Official Transcript of Proceedings
NUCLEAR REGULATORY COMMISSION

Title: Advisory Committee on Reactor Safeguards
 Thermal-Hydraulic Phenomena Subcommittee

Date: Monday, September 16, 2019

- Recap from April 2019 meeting
- Staff technical evaluation (TER) of in-vessel downstream effects (IVDEs) (ML19178A252)
- Comment/resolution since April 2019 meeting
- GL 2004-02 staff review guidance development

Comment/Resolution

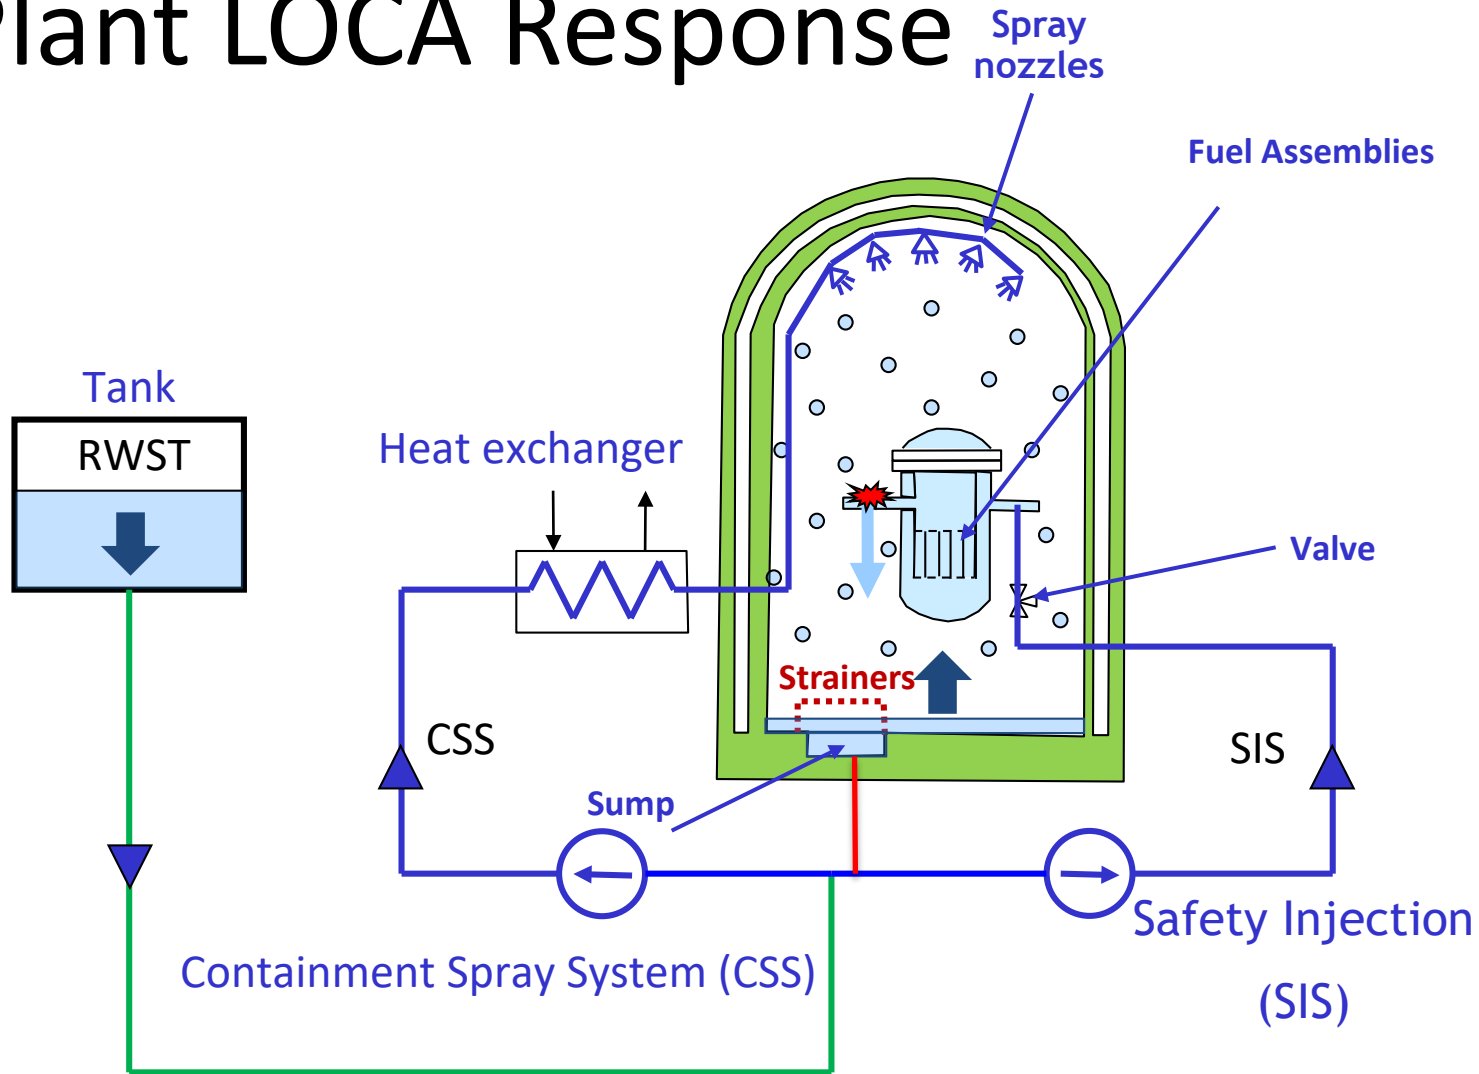
ACRS

- TER was revised to address ACRS comments:
 - **Clarified use of TRACE**
 - Staff verified 15 g/FA and 6-inch minimum break size
 - Additional information added to clarify brine testing
 - **Clarified TER safety significance statement**
 - Clarified HLSO based on BAP is in emergency operating procedures
 - Clarified t_{block} , t_{chem} , and K_{max}
 - Clarified why the CLB bounds the HLB
 - Clarified the use of STP assumption for lowest fibrous debris limit
 - Additional language added regarding uniform resistance calculations
 - Clarified that the use of risk numbers developed to define safety significance for use in the TER to define IVDEs only applies to this review
